Harmonization effort for
SGM-SF, RMS-MF and RMS-LB Mitigation Standards
Continuous maintenance efforts to improve these standards are currently ongoing.

This work contains proposed revisions for harmonization across Section 6, 7 and 8 compared to what is currently published in rev. 12/20 publications of: SGM-SF (existing homes); RMS-MF (existing multifamily buildings) and RMS-LB (existing schools and large buildings).

Public Review: 678 01-22
COMMENT DEADLINE: February 28th 2022

6.4.6 Separation from operable openings in structures

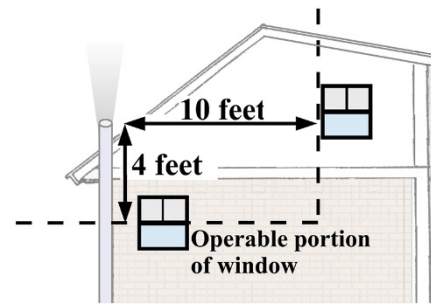
Rational/Commentary: This proposal addresses clarity for distance requirements.

- ~~b) not less than 4 feet (120 cm) above operable openings in structures~~
- b) not less than 4 feet (120 cm) away from operable openings in structures that are below the point of exhaust.

6.4.10 Roof

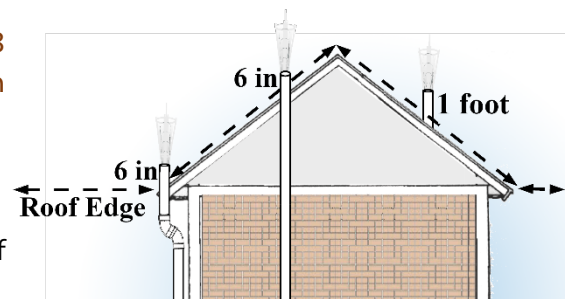
Rationale/Commentary: This proposal addresses clarity for distance and height requirements.

Additional Pic Needed

- a) not less than 1 foot (30 cm) above a pitched roof at the point penetrated;
- b) not less than 6 inches (15 cm) above the edge of the roof when ASD piping is attached to the side of a building;
- c) not less than 18 inches (46 cm) above a flat roof; and

- d) not less than 4 feet (120 cm) horizontally away from a vertical wall that extends above the roof edge.
